Date: 6th September 2016

RE: Planning Application APP/16/00820: Proposed erection of a detached two-bedroomed bungalow. Land adjacent 60 Gladys Avenue, Cowplain, Havant, PO8 8HS (former rear garden of 17 Lovedean Lane)

A drainage strategy has been submitted as part of the applicants planning submission, Document ref: D1154/DS/1.2 dated May 2016. Upon review of the document, I have the following comments:

Plan & Elevations 1:100

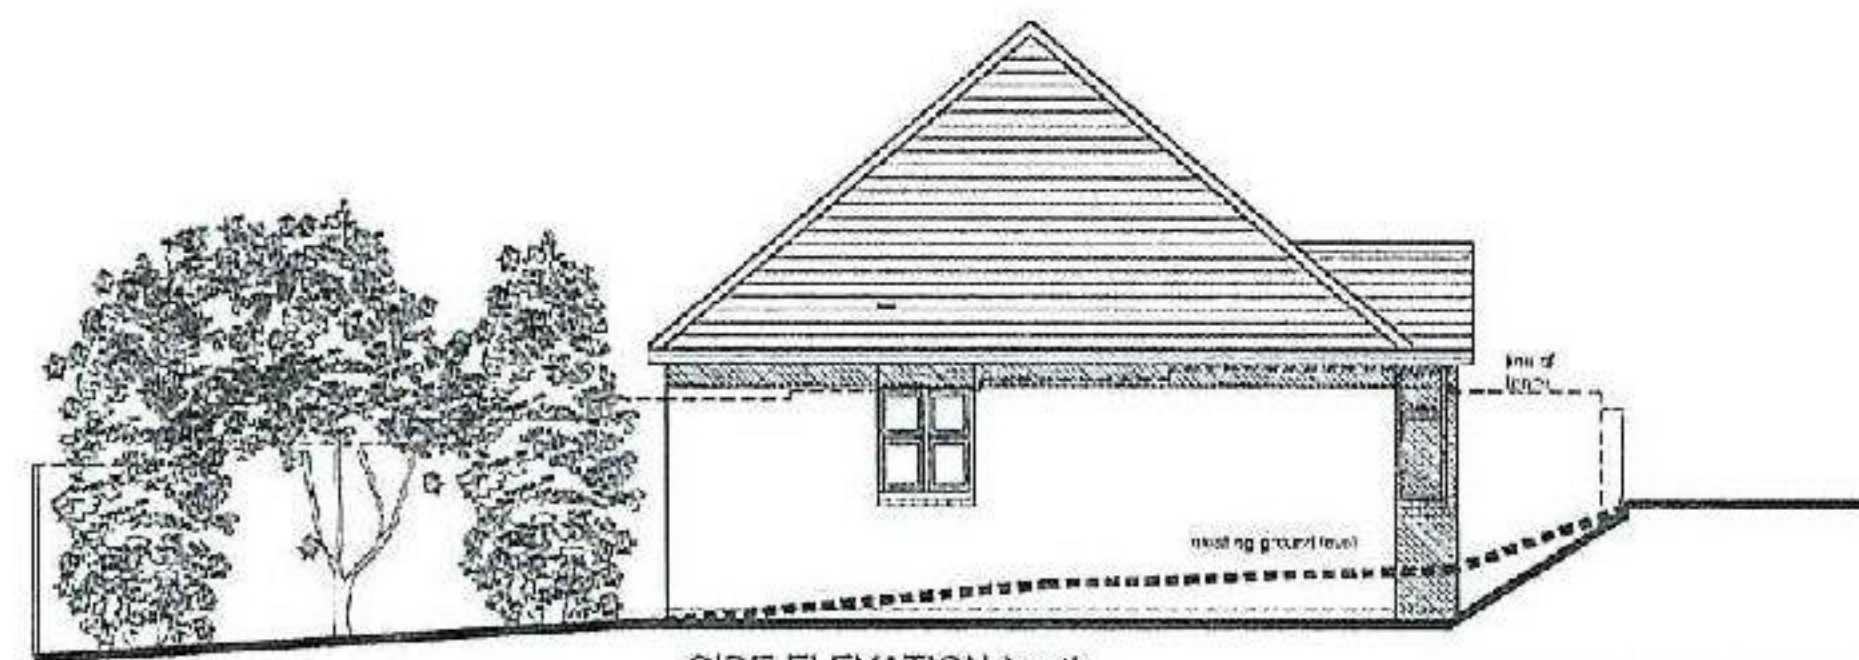
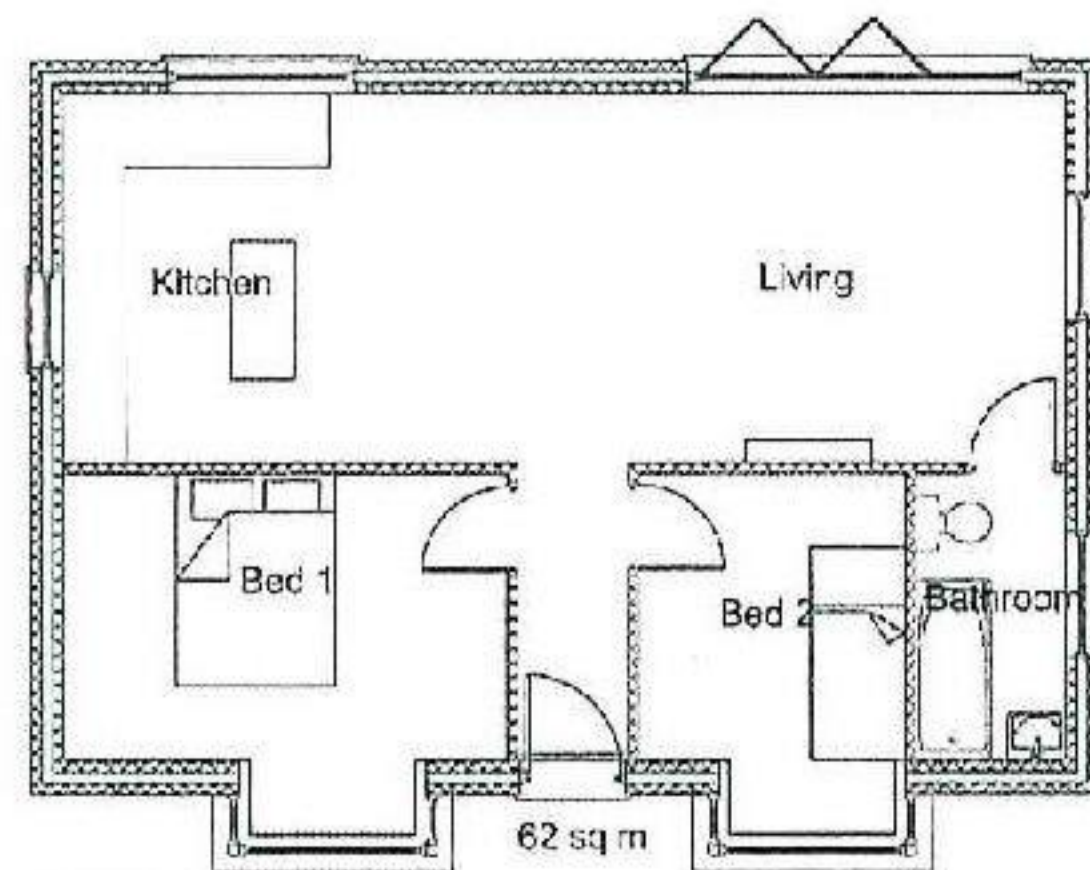
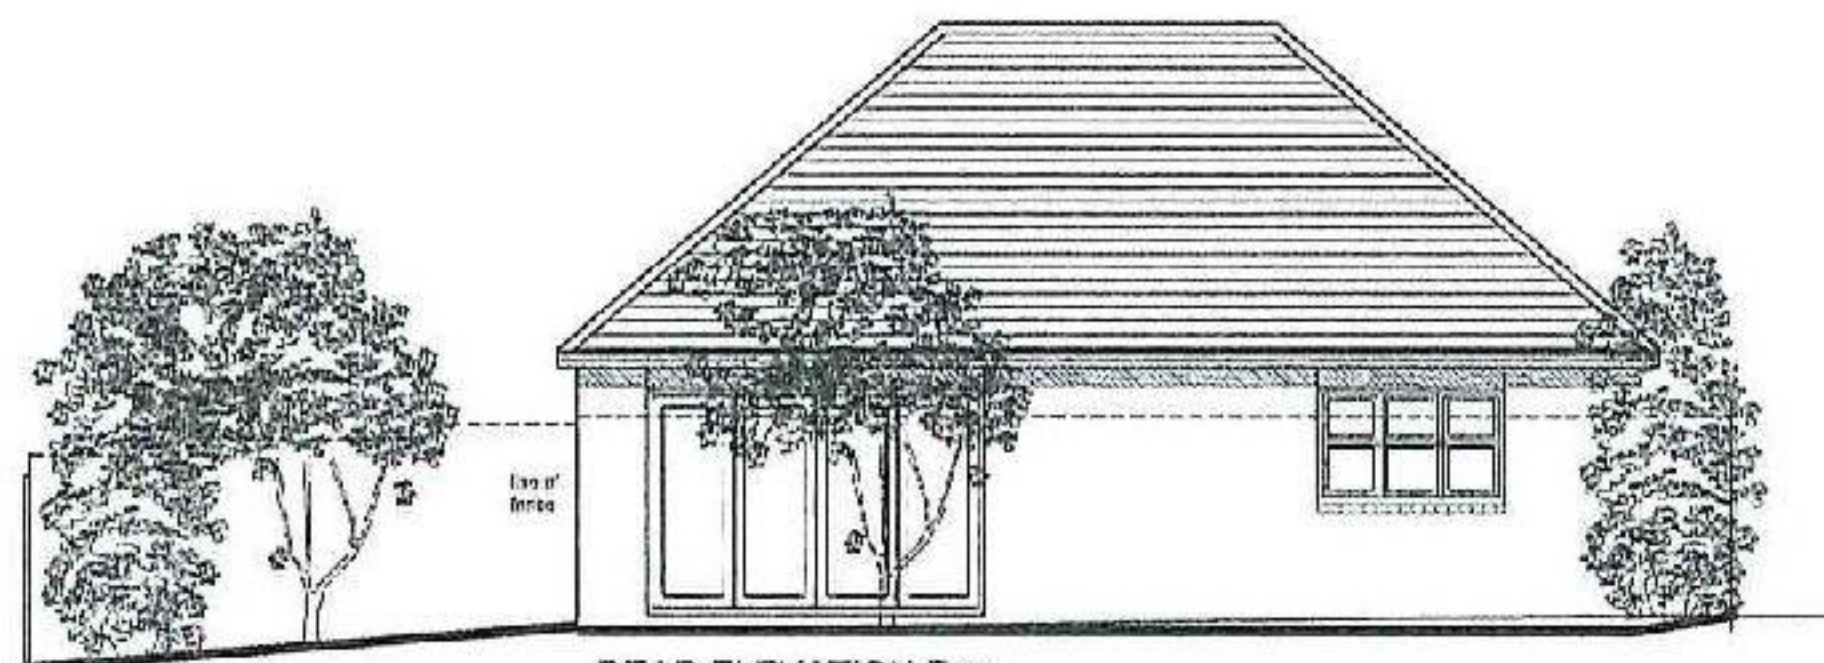
The proposed dwelling is a detached bungalow, yet its proportions are smaller than the neighbouring bungalows, semi-detached properties and a great deal smaller than our neighbouring detached property (refer to the aerial picture appended to the back of this letter for comparison). In the absence of submitted plans and elevations, looking at the drawing issued during the consultation stage, the proposed building is in excess of 5.6m high. Based on the finished floor level indicated on the drawing and a height of 1.8m of our fence, this extends 3.5m above the fence level. The proposed location of the buildings kitchen window looks directly into our property and extends in excess of 200mm above the fence level.

However, though the above finished floor level invert was taken from the consultation issue drawings, the level is contradicted within the applicants submitted drainage strategy. Within the

drainage strategy it states a finished floor level as 67.75, 0.75m higher than the drawings, compounding our concerns further in respect of being overlooked, invasion of privacy and loss of visual amenity. The proposed building would extend 4.25m above the level and the proposed location of the kitchen window not only looks directly into our property but would extend entirely above the fence level.

PHOTOGRAPH 1 - AERIEL VIEW VICINITY OF PROPOSED SITE AND EXISTING ADJACENT PROPERTIES

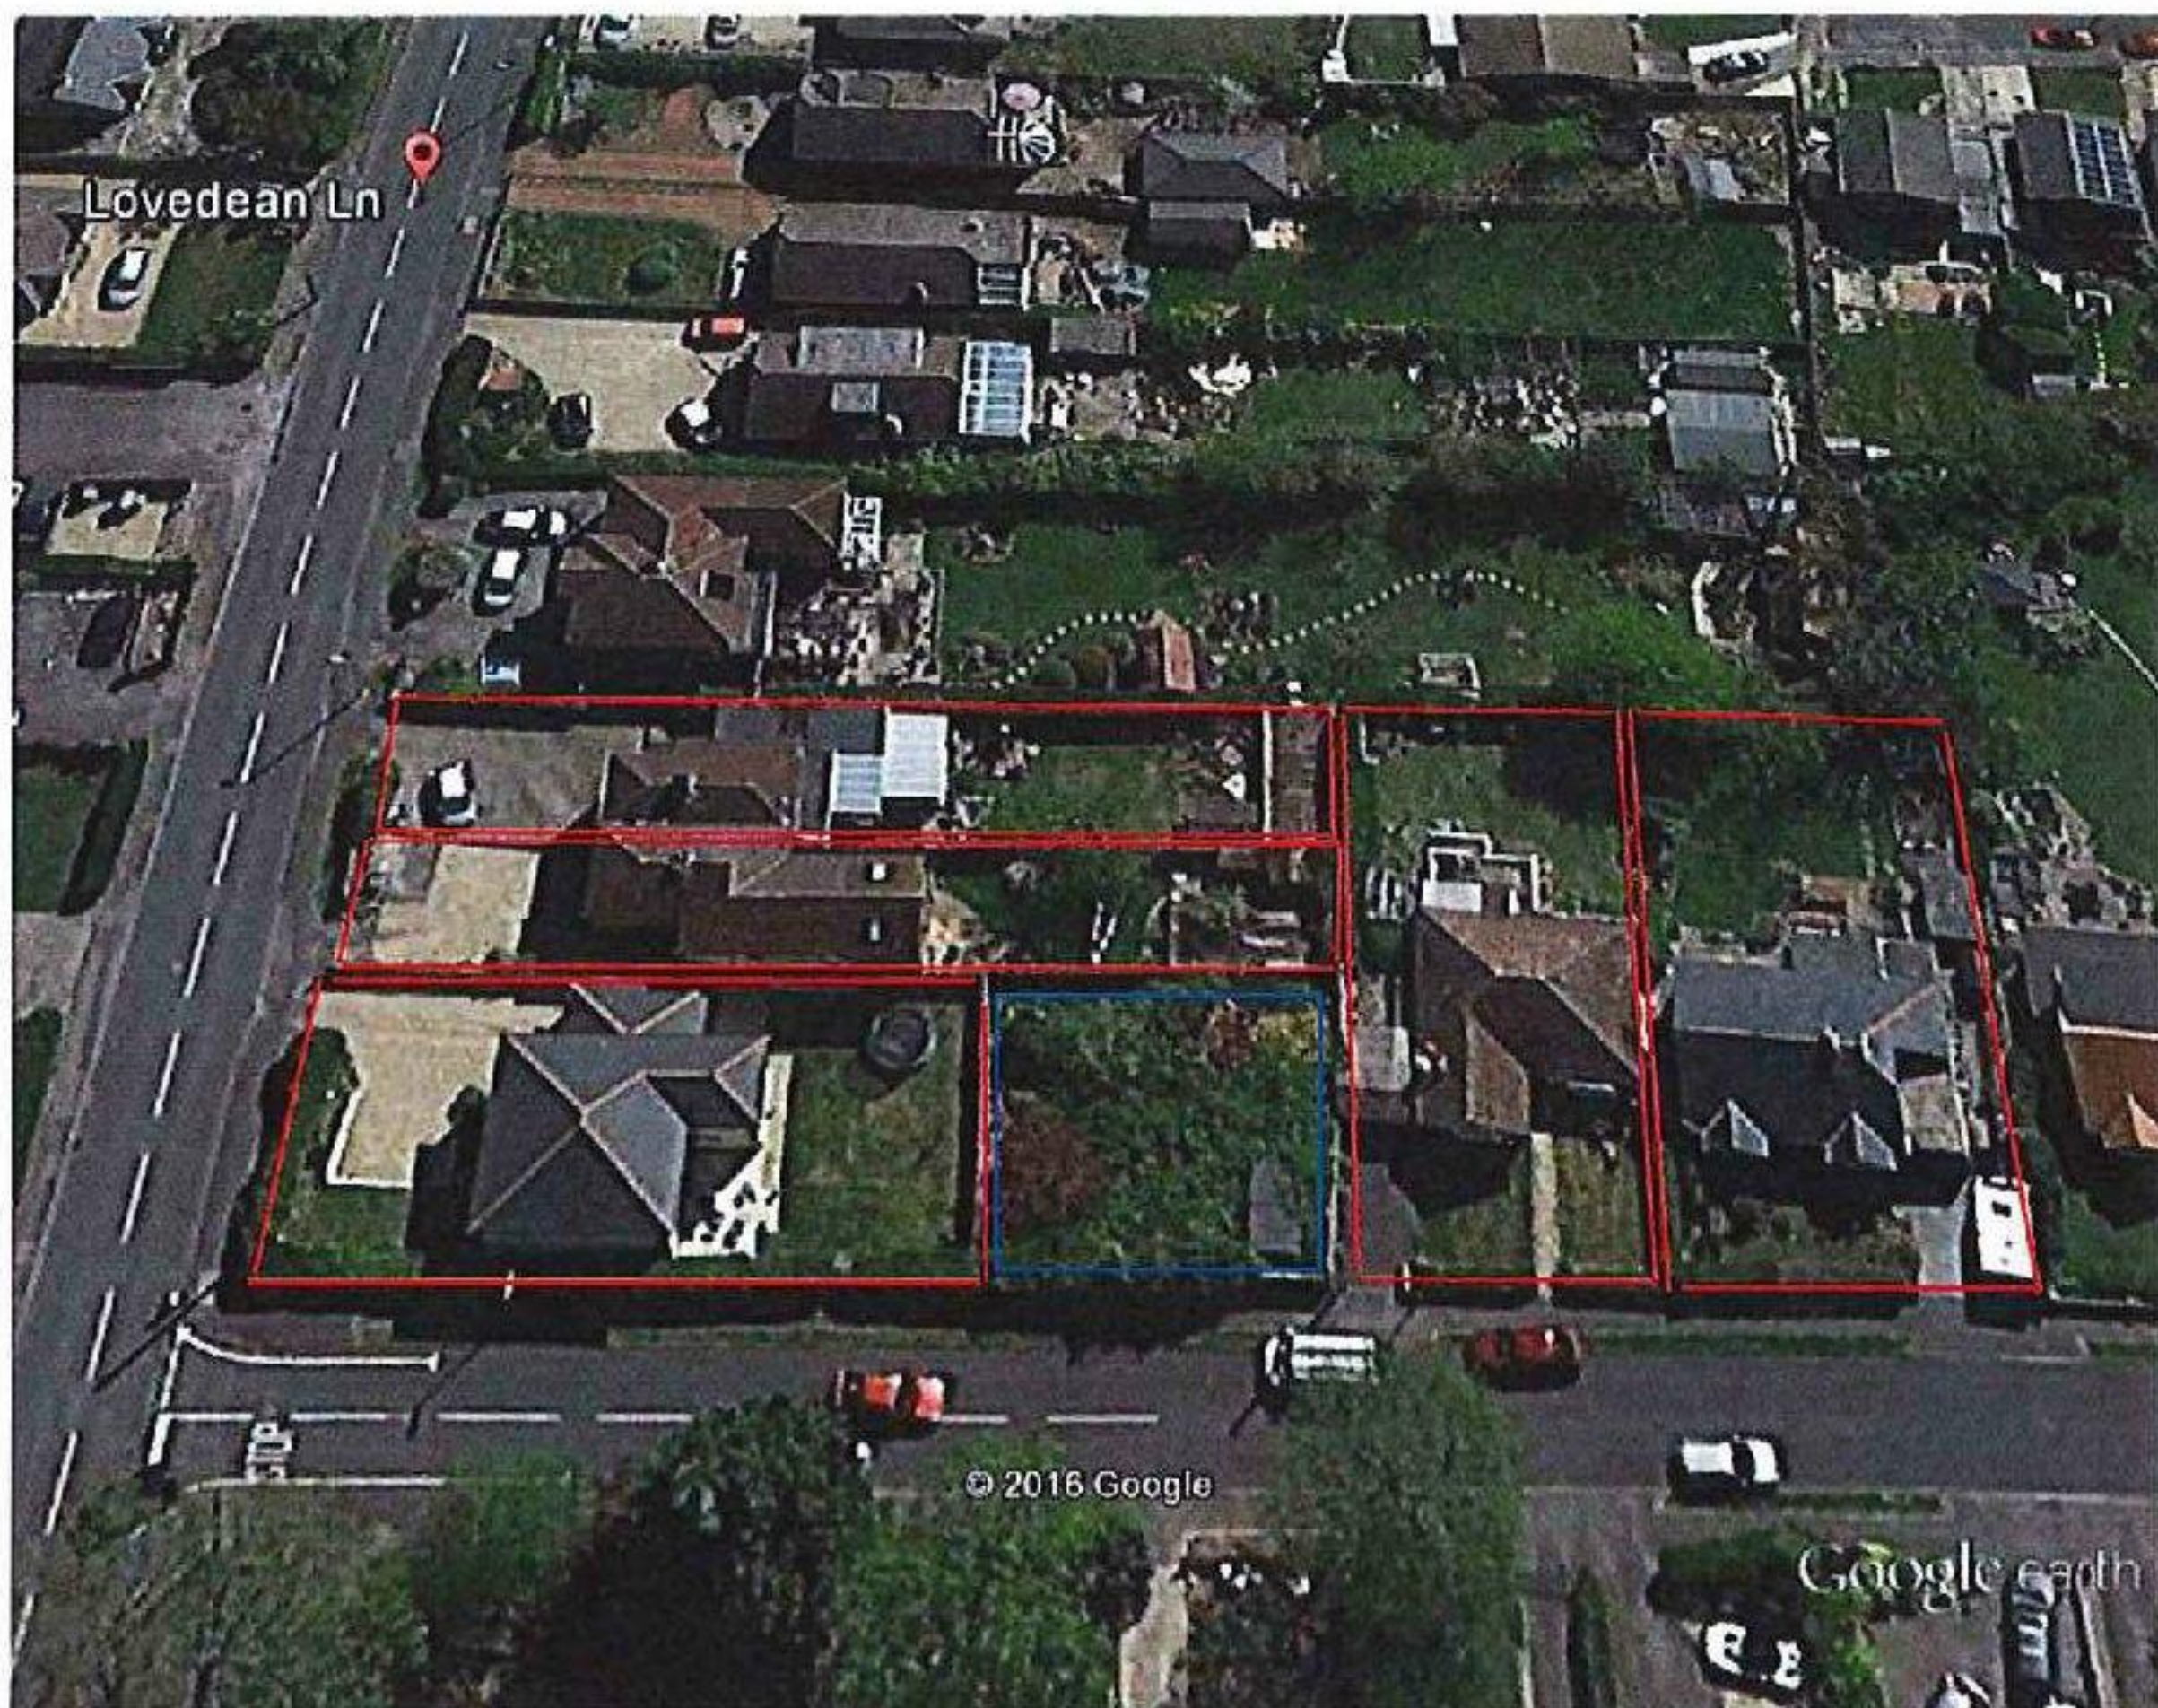
Within the applicants Planning, Design & Access Statement, it refers to the cover picture to illustrate the available plot/space. This picture is an historic picture and bears no resemblance to the present day. Please refer to Photograph 1 which is appended to the back of this letter. As can be seen, the actual plot available, formerly the garden of 17 Lovedean Lane, is very small and very much out of character with the other existing plots within Lovedean Lane and Gladys Avenue to even be considered for further development.

The properties along Gladys Road and Lovedean Lane are typically characterised by large plots with large spacing between (refer to the aerial picture Photograph 1 appended to the back of this letter). The proposed dwelling would be just 1.6m from Gladys Road and 5.6m from the boundary with 15 Lovedean Lane and just over 1m from the boundary with our property 17 Lovedean Lane. Not 2.144m to Gladys Road and 6.038m to the boundary with 15 Lovedean Lane as indicated on the site plan.
